Memorandum Community & Economic Development Department

To: Randall Tweet, Interim City Manager
Subject: Dunkin Donut restaurant at 2711 18th Ave.
Date: May 8th, 2017

Subject: Case #2017- Review of Site Plan at 2711 18th Avenue.

DUNKIN' DONUTS
LOT 2 CVS PHARMACY
ROCK ISLAND SUBDIVISION
ROCK ISLAND, ILLINOIS
SITE PLAN

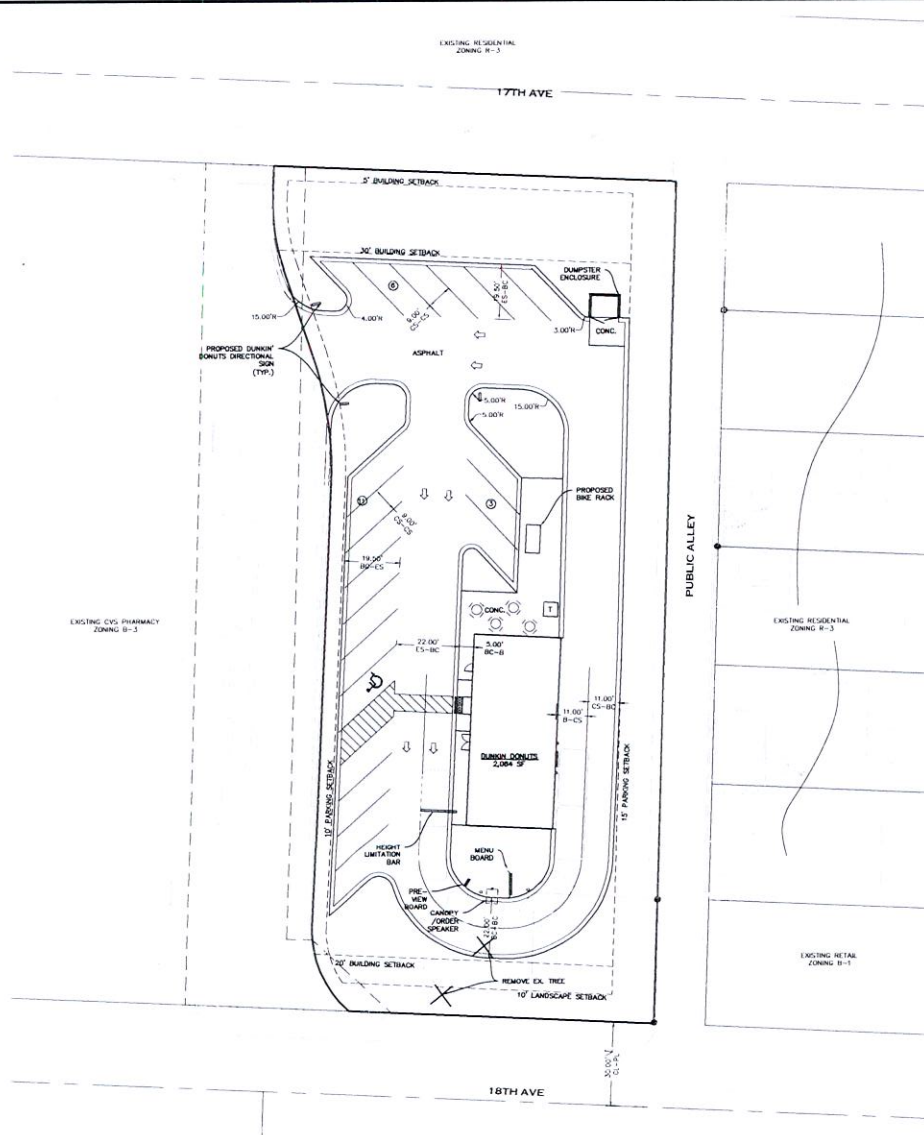
The site has frontage on 17th and 18th Avenues. There will not be a new access point onto either of these public streets. Access to the site will be via the private drive that bi-sects the CVS and development sites. The site plan identifies one driveway access near the northwest corner of the site off of a private north/south drive (see site plan).

The proposed structure meets all building setback requirements in the Zoning Ordinance. The north and south side of the development are both defined as front yards under zoning regulations. The B-3 zoning district requires a 20-foot front yard setback requirement when adjacent to business zoning and a 25 foot front yard when adjacent to residential zoning. The site plan identifies an approximate 238 foot north front yard and an approximate 70 south front yard. The west yard is a side yard and since it is adjacent to business zoning there is no building setback requirement in that yard. The site plan identifies a 46.5 foot west side yard building setback. The east yard is adjacent to R-3 (one and two family residential) zoning and requires a 30 foot building setback since it is adjacent to rear yards of residential zoning. The site plan identifies a 37 foot east side yard building setback.

The Zoning Ordinance requires one space for every 75 square feet of public floor area. Based on 590 square feet of inside public floor area and four outside eating table a total of 12 parking spaces should be provided. The site plan identifies 20 parking spaces. There is also a drive-thru lane that curves around the structure from west to east that has space for at least 8 stacking spaces (six stacking spaces is the minimum required by the Zoning Ordinance).

DUNKIN DONUTS
LOT 2 CVS PHARMACY
ROCK ISLAND, ILLINOIS
LANDSCAPE PLAN
COVER SHEET

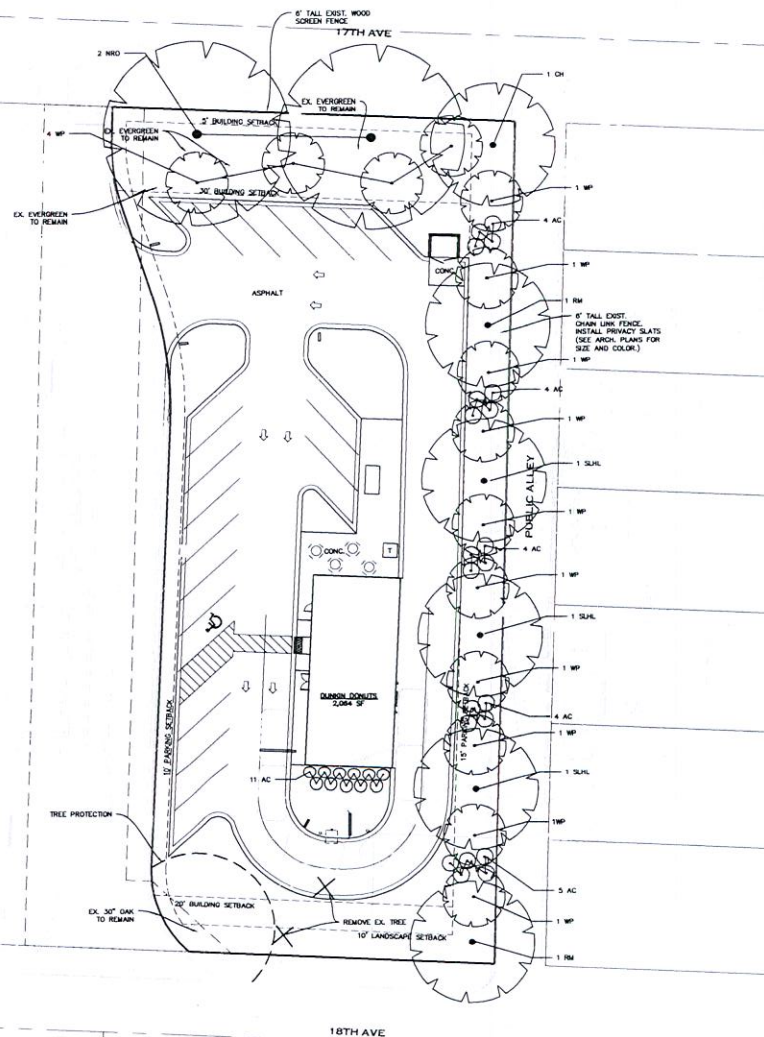
The proposed landscape plan is attached and meets Zoning Ordinance requirements for a “type C (15 foot wide) bufferyard” on the north and east side of the site. CVS already located a 6 foot privacy fence along the north property line of the subject site that will remain and will reduce the required number of plantings in this area. CVS planted four evergreen trees in the north yard of the subject site that will remain and the applicant will plant two canopy trees (northern red oak) and

four new white pine trees in this north yard (total of 8 evergreens will be located in north bufferyard).

There is also an existing 6 foot tall chain link fence along the east property line adjacent to the alley. The fence will remain and be updated with slats to make it an opaque fence that will provide a visual and noise buffer to the east. This will also reduce the required number of landscape requirements in the east 15 foot wide bufferyard. Landscaping identified along the east bufferyard includes 6 canopy trees (red maple, common hackberry and skyline honey locust), 10 white pine evergreen trees with 21 shrubs.

The west and south yards are adjacent to business uses and zoning. CVS was not required to locate any landscaping along its eastern edge adjacent to the private drive and the applicant will also not be required to provide landscaping along the western edge of the subject site. The south yard also does not require any landscaping because there is not a parking lot in the front yard as is typical for many business locations, but the applicant has agreed to maintain a mature oak tree at the southwest corner of the subject site. Two smaller trees will be removed adjacent to this tree because they will make the structure and signs less visible from 18th Avenue. Eleven shrubs will also be located along the south building façade.

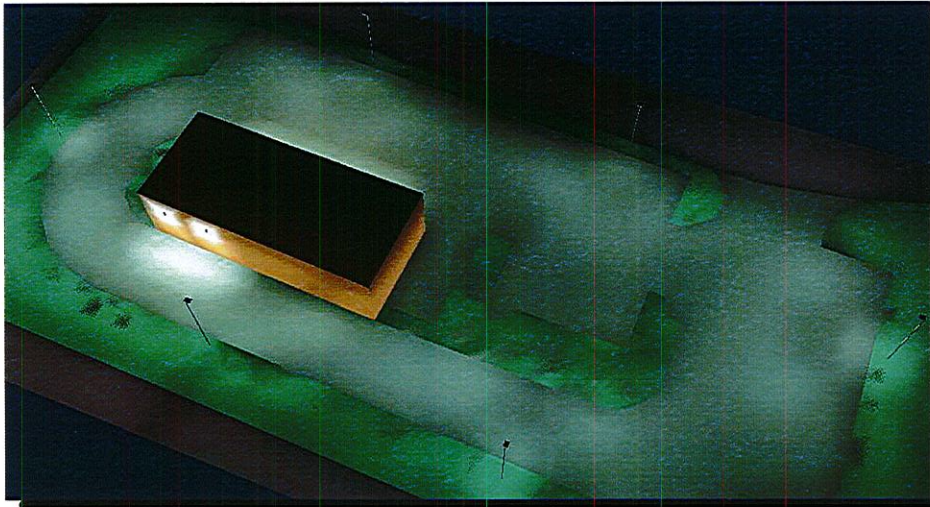
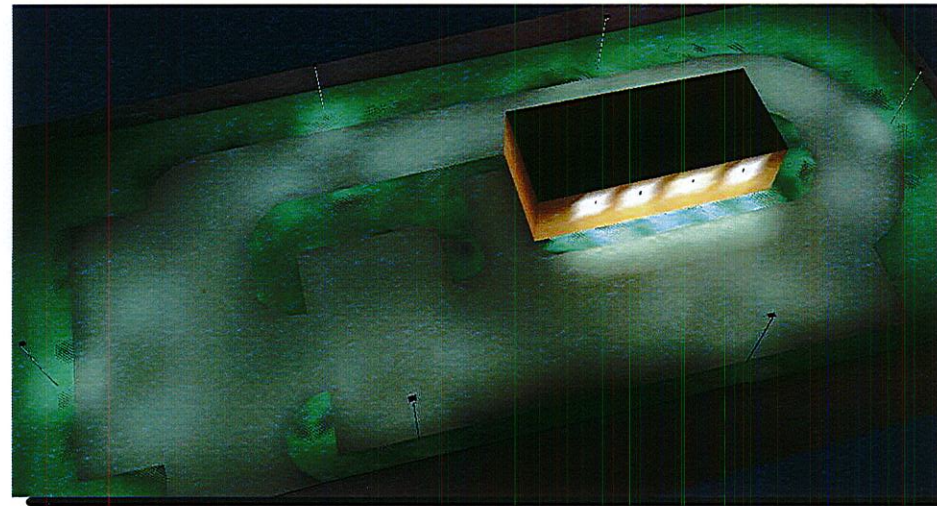
Final comments about traffic and lighting were made. Lee Fry Companies agreed per city engineering approval to add an additional speed bump at the stop sign for a total of two. Clarification to the photometric plan was provided showing footcandles on the north side at a level of 0.2 much less then the permitted 1.

The applicant has indicated that lighting for the site includes 6 building lamps and 6 light standards in the parking lot with 90 degree lamp design with back shields on the eastern side of the site (see attachments). All proposed lighting (with proposed shields on east side light standards) will meet Zoning Ordinance requirements of a level of one footcandle at property lines.
